Project	IEEE 802.16 Broadband Wireless Access Working Group < http://ieee802.org/16 >	
Title	Modified TEK State Machine for the MBRA (Multicast & Broadcast Rekeying Algorithm)	
Data Submitted	2004-11-04	
Source(s)	Seokheon Cho SungCheol Chang Chulsik Yoon, ETRI	Voice: +82-42-860-5524 Fax: +82-42-861-1966 chosh@etri.re.kr
	161, Gajeong-dong, Yuseong-Gu, Daejeon, 305-350, Korea	
Re:	IEEE 802.16 Security Ad Hoc	
Abstract	The modified TEK state diagram and TEK state transition for the efficient rekeying method for the multicast service and the broadcast service	
Purpose	The document is submitted for review by 802.16 Working Group members	
Notice	This document has been prepared to assist IEEE 802.16. It is offered as a basis for discussion and is not binding on the contributing individual(s) or organization(s). The material in this document is subject to change in form and content after further study. The contributor(s) reserve(s) the right to add, amend or withdraw material contained herein.

Modified TEK State Machine for the MBRA

Seokheon Cho, SungCheol Chang, and Chulsik Yoon
ETRI

Figure 132a-TEK state machine flow diagram

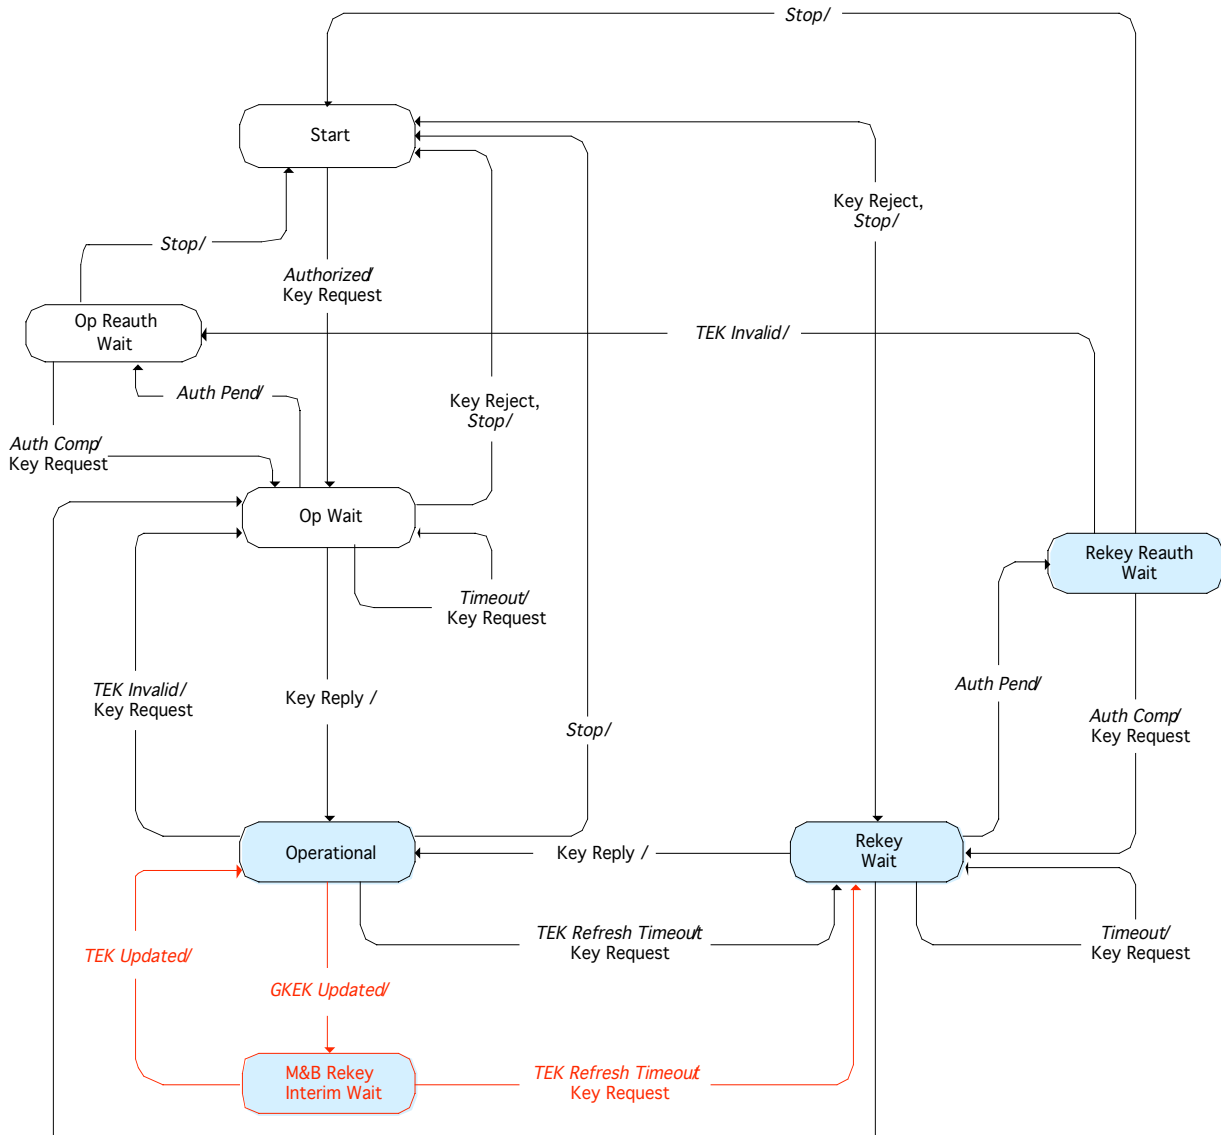
The TEK state machine consists of ~~six~~ **seven** states and ~~nine~~ **eleven** events (including receipt of messages) that can trigger state transitions. Like the Authorization state machine, the TEK state machine is presented in both a state flow diagram (Figure 132a) and a state transition matrix (Table 132a). As was the case for the Authorization state machine, the state transition matrix shall be used as the definitive specification of protocol actions associated with each state transition.

Shaded states in Figure 132 (Operational, Rekey Wait, ~~and Rekey Reauthorize Wait~~ **Rekey Reauthorize Wait**, and M&B Rekey **Interim Wait**) have valid keying material and encrypted traffic can be passed.

M&B Rekey Interim Wait (Multicast & Broadcast Rekey Interim Wait): This state is defined only for the multicast service or the broadcast service. This state is the wait state the TEK state machine is placed in if the TEK state machine has valid traffic keying material and receives the new GKEK from the BS.

GKEK Updated: This event is triggered when the SS receives the new GKEK through the Key Update Command message for the GKEK update mode.

GTEK Updated: This event is triggered when the SS receives the new GTEK and traffic keying material through the Key Update Command message for the GTEK update mode.

7-G M&B Rekey Interim Wait (*TEK Refresh Timeout*) -> Rekey Wait

10-D Operational (*GKEK Updated*) -> M&B Rekey Interim Wait

11-G M&B Rekey Interim Wait (*GTEK Updated*) -> Operational

- a) send Key Request message to BS
- b) set Key Request retry timer to Rekey Wait Timeout

- a) process contents of Key Update Command message for the GKEK update mode and incorporate new GKEK into key database

- a) clear Key Request retry timer
- b) process contents of Key Update Command message for the GTEK update mode and incorporate new traffic keying material into key database
- c) set the TEK refresh timer to go off "TEK Grace Time" seconds prior to the key's scheduled expiration
